## Product / Process Change Notification (PCN)

**PCN #:** PCN\_UtRJ45LAN\_20181008

**Affected Series:** WE-RJ45LAN; 7499xxx

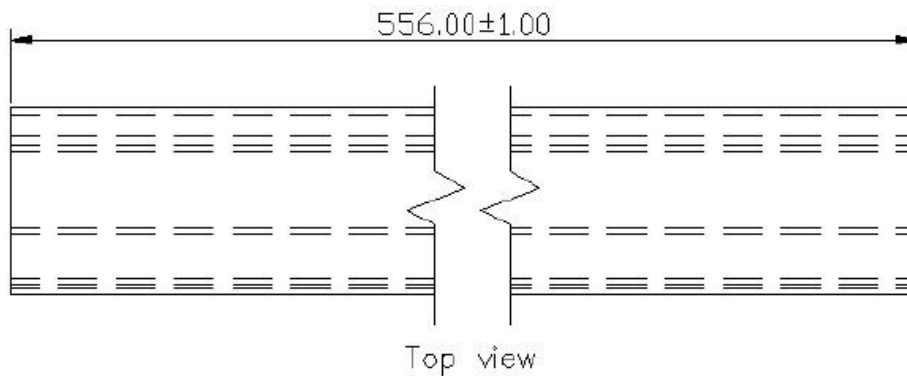
The tube lengths will be changed from 556.00 ±1.00 mm to 530.00 ±1.00 mm.

| <p><b>OLD</b></p> <p>556.00±1.00</p> <p>Top view</p>  | <p>Affected part numbers:</p> <p>7499110120<br/>7499210123<br/>7499210210<br/>7499010122<br/>7499010126<br/>7499010124</p> |

| <p><b>NEW</b></p> <p>For the part numbers on the right column, the packaging quantity won't change</p> <p>530.00±1.00</p> <p>Top view</p> |  |

**NEW**

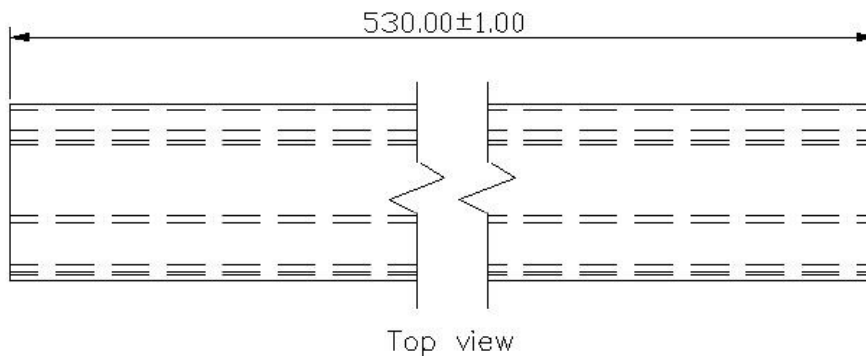
**OLD**

Affected part numbers:

7499012000  
74990110013  
7499010213  
7499010005  
7499011215  
7499111213  
7499111443  
7499011002  
7499011121  
7499011215  
7499011125  
74990112120  
7499111990  
7499210121  
7499210122  
7499210211  
7499211121  
7499211123  
7499012121

For the part numbers on the right column, the packaging quantity won't change

## OLD

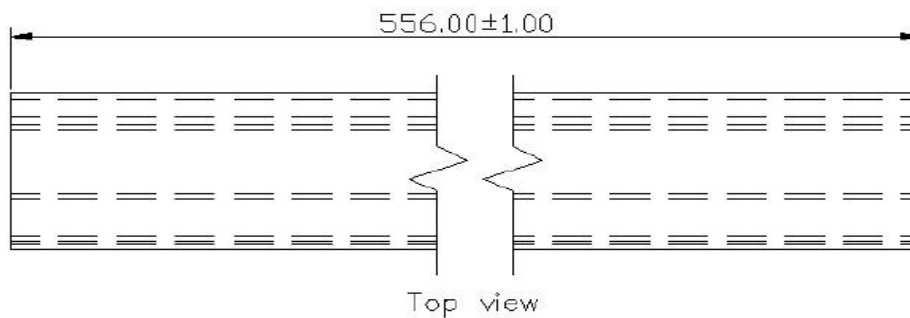
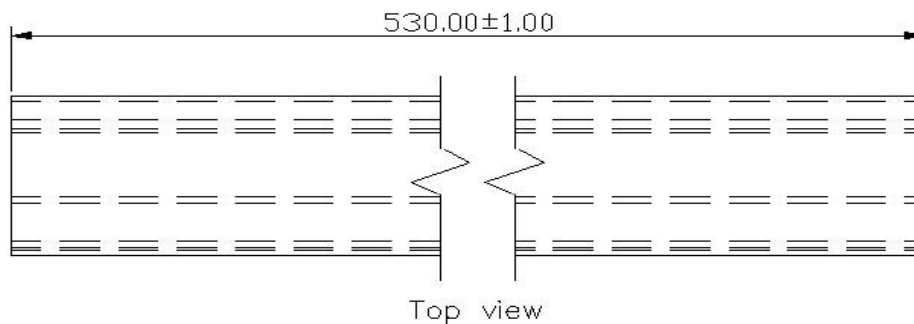
Packaging quantity:

**20 pcs.** per tube

**20 tubes** (=400 pcs. per carton)

Affected part numbers:

Packaging quantity:

**19 pcs.** per tube

**20 tubes** (=380 pcs. per carton)
